Product Change Notice: Packaging Change: Multiple SMD Lytic Series

PCN.PG25.07.05.2017

07.05.2017

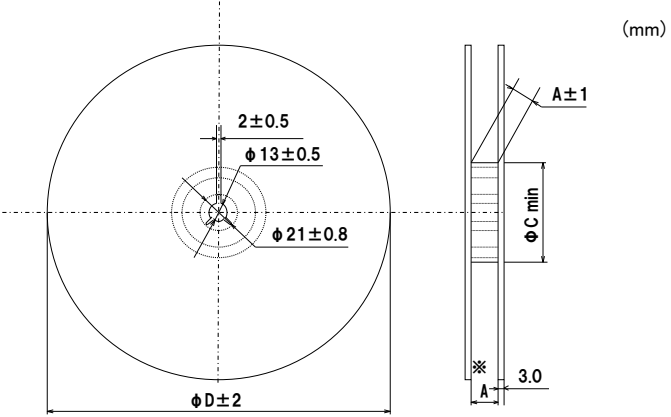
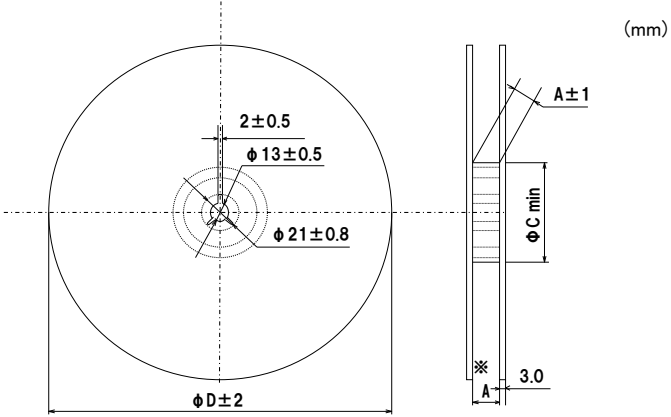
About This Notice:	<p>Panasonic will change the reel material from Paper to Plastic. The purposes of the reel change are:</p> <ol style="list-style-type: none"> 1. increasing demand for plastic reels especially in automotive industry 2. increasing demand for plastic reels in surface-mount type Capacitors 3. to reduce dust in Panasonic production lines coming from paper reels
Effective Date:	<p>The change will start for the products to be shipped on September 1, 2017.</p>
Change Details:	<p>The reel material of reel will change from Paper to Plastic</p>
Affected Parts:	<p>See Attached.</p>
Datasheet(s):	<p>N/A</p>
Notes:	<p>Parts numbers: Not Changed Characteristics: Not Changed (just a change of packaging reel) Packaging Qty: Not Changed</p>

Current	New																																																																
Appearance																																																																		
Dimensions	 <p>(mm)</p> <table border="1"> <thead> <tr> <th>Size code</th> <th>A</th> <th>C</th> <th>D</th> </tr> </thead> <tbody> <tr><td>B</td><td>14</td><td>50</td><td>380</td></tr> <tr><td>C</td><td>14</td><td>50</td><td>380</td></tr> <tr><td>D</td><td>18</td><td>50</td><td>380</td></tr> <tr><td>D8</td><td>18</td><td>50</td><td>380</td></tr> <tr><td>E</td><td>18</td><td>50</td><td>380</td></tr> <tr><td>F</td><td>26</td><td>50</td><td>380</td></tr> <tr><td>G</td><td>26</td><td>50</td><td>380</td></tr> </tbody> </table> <p>Dimension※ does not exceed 1.5 times of A.</p>	Size code	A	C	D	B	14	50	380	C	14	50	380	D	18	50	380	D8	18	50	380	E	18	50	380	F	26	50	380	G	26	50	380	 <p>(mm)</p> <table border="1"> <thead> <tr> <th>Size code</th> <th>A</th> <th>C</th> <th>D</th> </tr> </thead> <tbody> <tr><td>B</td><td>14</td><td>50</td><td>380</td></tr> <tr><td>C</td><td>14</td><td>50</td><td>380</td></tr> <tr><td>D</td><td>18</td><td>50</td><td>380</td></tr> <tr><td>D8</td><td>18</td><td>50</td><td>380</td></tr> <tr><td>E</td><td>18</td><td>50</td><td>380</td></tr> <tr><td>F</td><td>26</td><td>50</td><td>380</td></tr> <tr><td>G</td><td>26</td><td>50</td><td>380</td></tr> </tbody> </table> <p>Dimension※ does not exceed 1.5 times of A.</p>	Size code	A	C	D	B	14	50	380	C	14	50	380	D	18	50	380	D8	18	50	380	E	18	50	380	F	26	50	380	G	26	50	380
